Technical Bulletin

PAGE: 1/1

| Model: Gim-MF1 d/dM | Date: 25-Jun-15 | No.: RM160022a |

| Subject: Dirty reverse side of printing sheets | | | Prepared by: J.Kitagawa | |

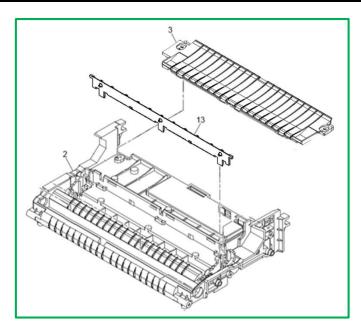
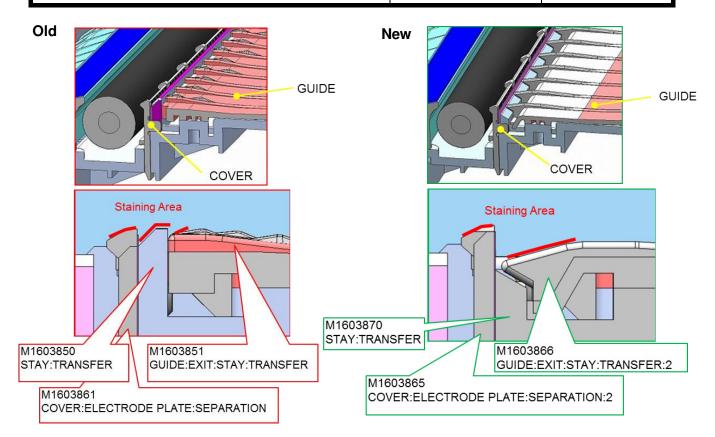
Change: The shapes and/or material of the following parts were changed.

- 1. The maximum height of the guide rib of the exit guide stay was shortened.
- 2. The material and shape of the electrode plate cover was changed.
- 3. The shape of the transfer stay was changed as shown in the illustration.

Reason: To further minimize staining on the printed paper.

Note: The reverse side of the printed sheets may get dirty when the sheets pass through the area indicated in the illustration.

Important: These three parts need to be installed **together as a set.**

| Subject: Parts catalog correction | | | Prepared by: H.K. | | |

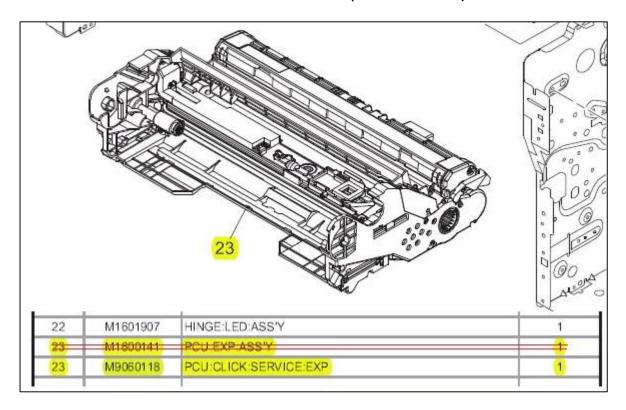
Change: The PCU: EXP:ASS'Y for the User Maintenance Model SP 4510SF was deleted.

Reason: This assembly will not be registered as a service part.

Important: For the Meter Click/Meter Charge model MP 401SPF, use "PCU:CLICK:SERVICE:EXP" (P/N M9060118).

| Model: Gim-MF | -1d/dM | | Da | ate: 25-Jun- | 15 | No.: RM160027 |
|---|--------------------------------|-----------------------------|------|--------------|--------|-------------------------------|
| Subject: Part catalog correction "Fusing Section 1" Prepared by: J.Kitagawa | | | | | | |

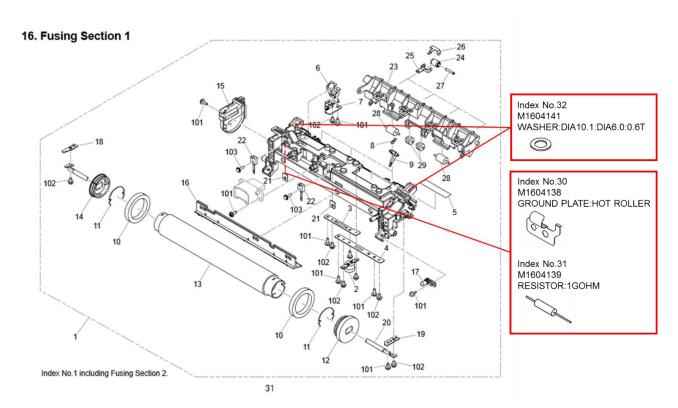
Change: Geometry of these parts were changed.

SYMPTOM

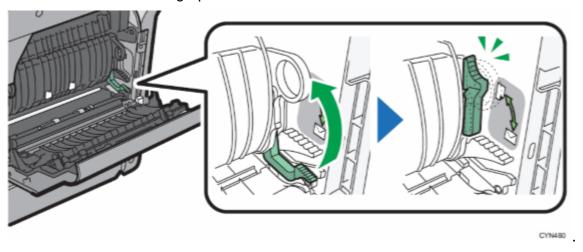
Toner is not properly fixed when printed on a recommended type of plain paper.

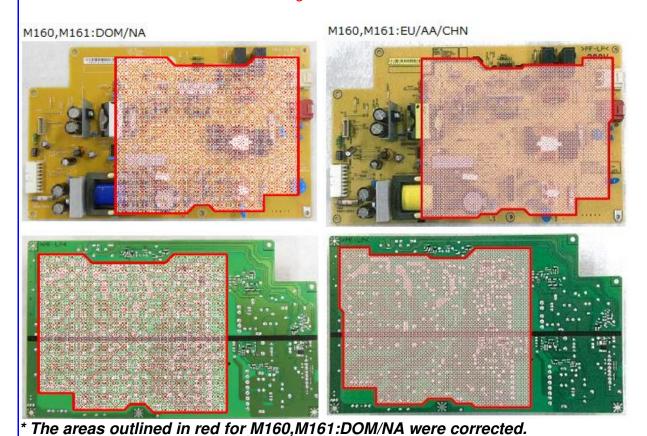
⚠ CAUTION:

Text within the red frame have been added.

Pasting Position of Sponge and Sheet

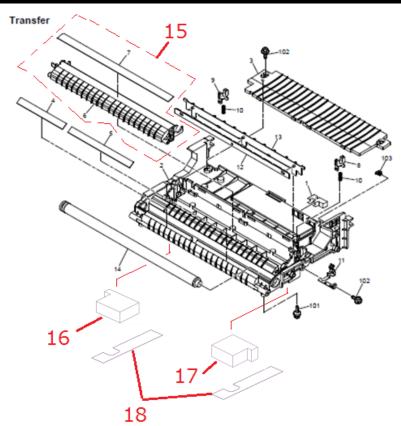
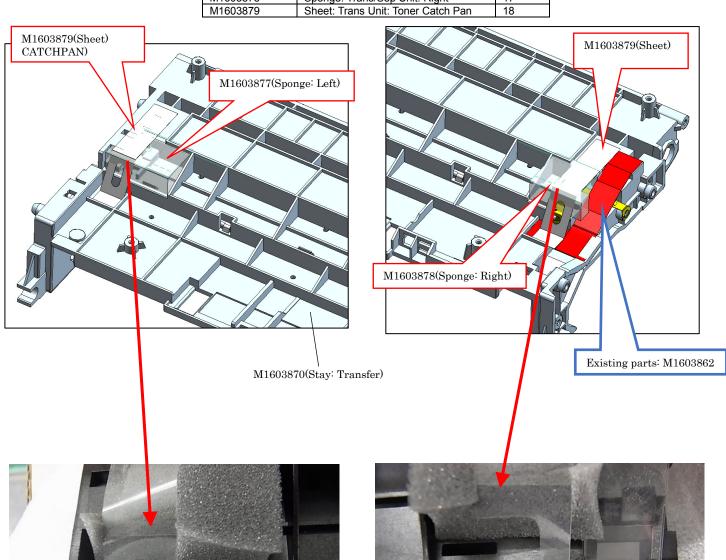
Change

- A cut-out was applied to the right and left edges of the front paper guide of the transfer roller
- Sponges and sheets were added to the transfer stay.

With this modification, dropped toner goes around the right and left edges of the front paper guide and accumulates on the transfer stay.

This modification has compatibilities. Since the old transfer stay cannot be replaced in the field and the stay of the old type is compatible only with the front paper guide of the old type, when replacing the front paper guide of an old machine, make sure to procure the old type.

This modification allows usage of the PCDU even after exceeding 23K by modifying SP5-931-003. However, DO NOT modify this SP on machines manufactured prior to this modification, because the front paper guide and transfer stay are both of the old type and will cause toner accumulation on the front paper guide when reaching approximately 23K.

Cleaning of the front and rear transfer roller guides is not mandatory for machines applied of this modification. However, note that the cleaning is mandatory for the machines manufactured prior to this design modification.

2. Installation > IC card reader

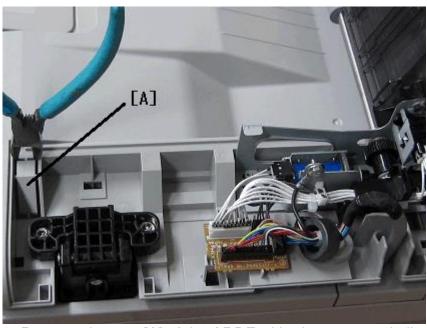
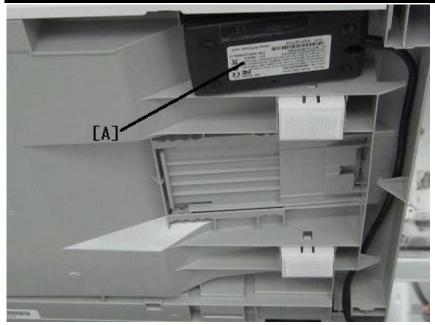
Please add the following installation procedure in the field service manual in this section:

For users who wish to use the IC card reader, install the card reader using the following procedure.

1. Remove the ARDF rear cover. (See page 191.)

2. Remove the part [A] of the ARDF with nippers or a similar tool.

3. Attach the IC card reader [A].

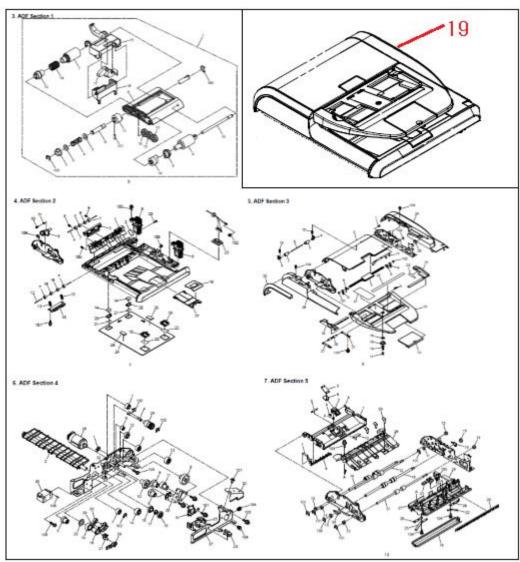
Change/Reason: The ADF Ass'y was added as a service part.

SYMPTOM

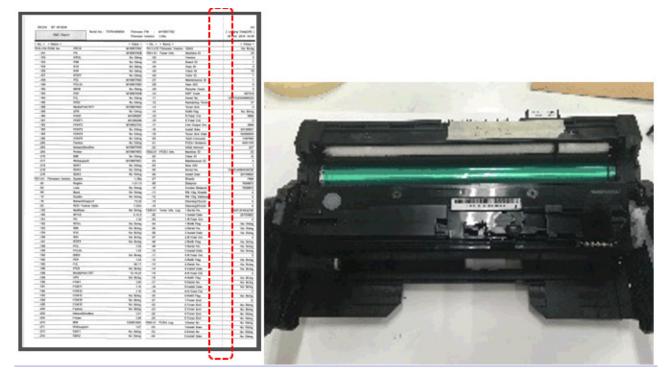
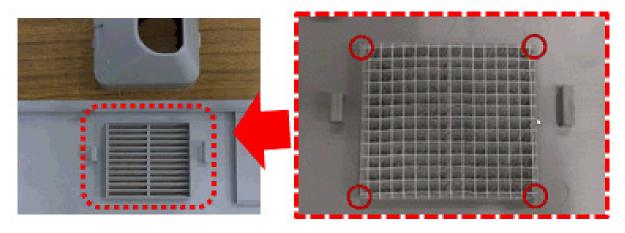
Black line or white line appears on prints in the feeding direction along with unwanted toner on the charge cleaning roller at the line position.

A filter sheet is added to prevent the entry of abnormal substances coming from the intake fan.

SYMPTOM

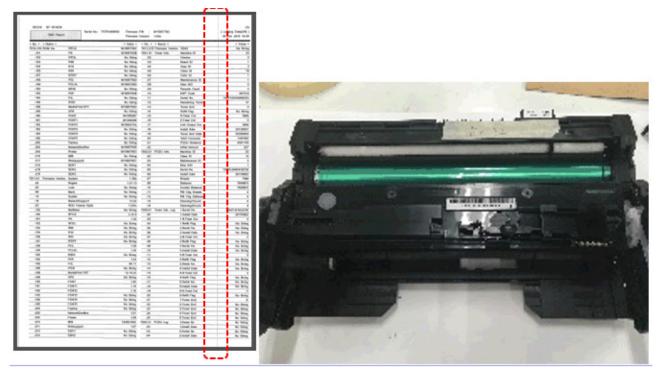
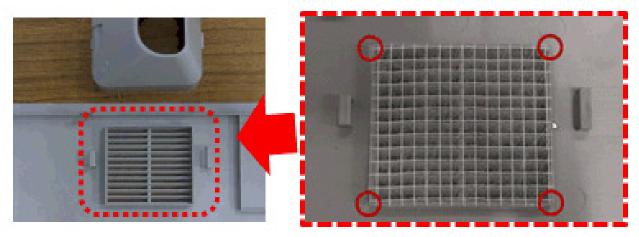
Black line or white line appears on prints in the feeding direction along with toner on the charge cleaning roller at the line position.

Abnormal substance comes inside from the intake fan, then it adheres on the drum. Then the abnormal substance which adheres to the drum is caught and/or chips the cleaning blade.

At such a location, the cleaning blade cannot clean toner out from the PCDU, causing black lines on prints. Gradually this toner transfers to the charge roller and charge cleaning roller. When it comes to a certain level, the charge roller cannot charge sufficiently, causing white lines on prints.

A filter sheet is added to prevent the entry of abnormal substances coming from intake fan.

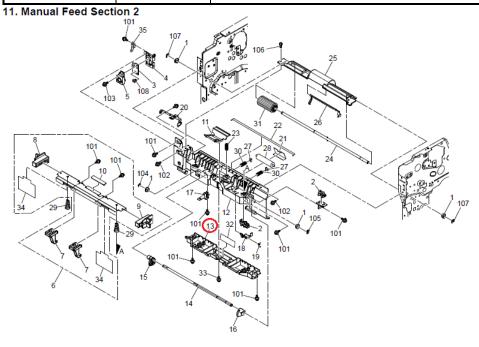
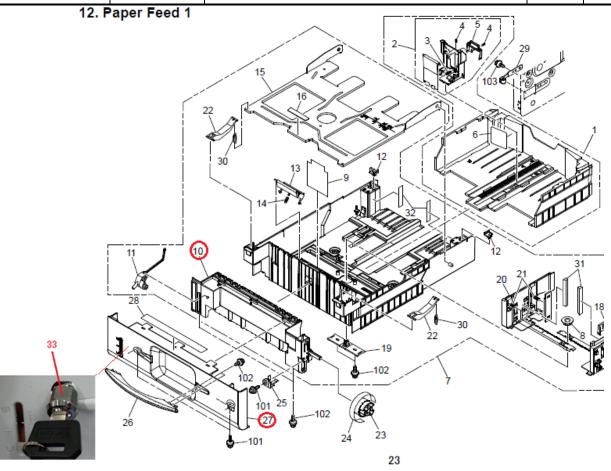
Gim-MF1d HC model TE (M160-13) was added to the Gim-MF1d, targeting only the NA market.

Due to this addition, the Parts Catalog for M160 was revised.

Note: The key (p/n: M3752570) comes with two spare keys.

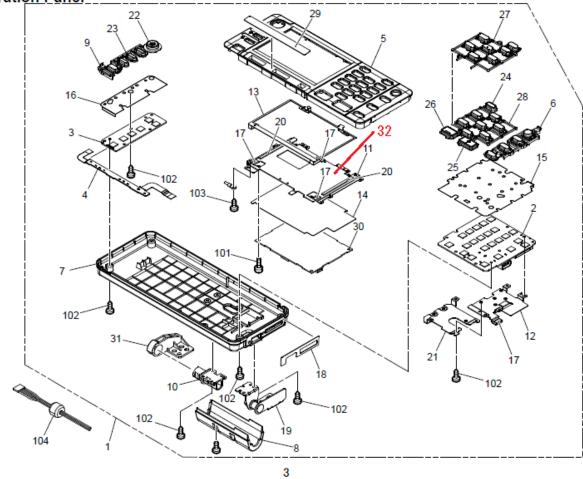
Change/Reason: The LCD was added as a service part.

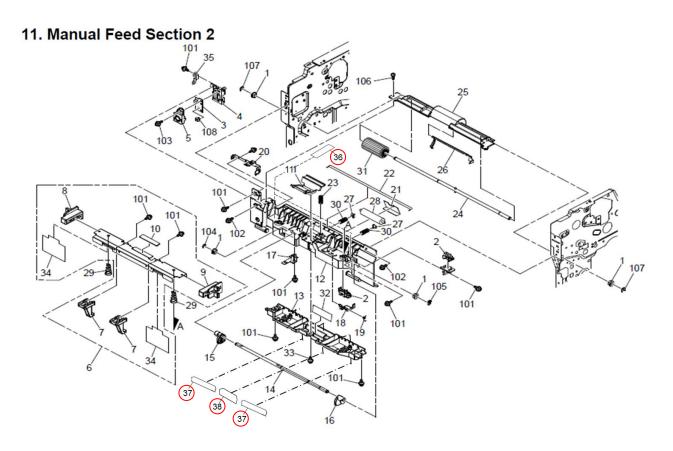
Change: The following parts were registered as service parts.

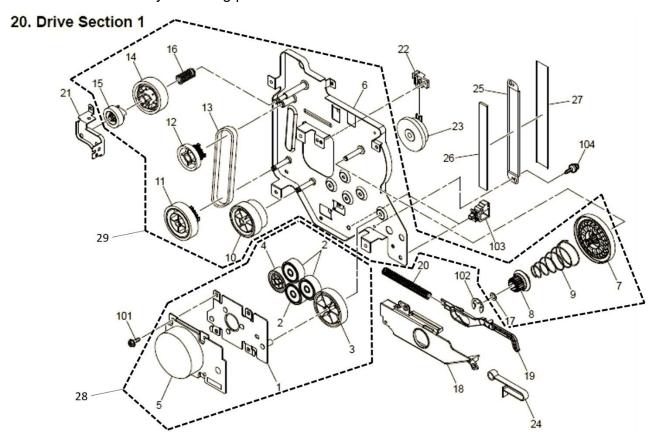
Change: The following parts were registered as service parts.

P/N M0A00035 is assy including parts from index 1 to 5.

P/N M1600036 is assy including parts from index 6 to 17.
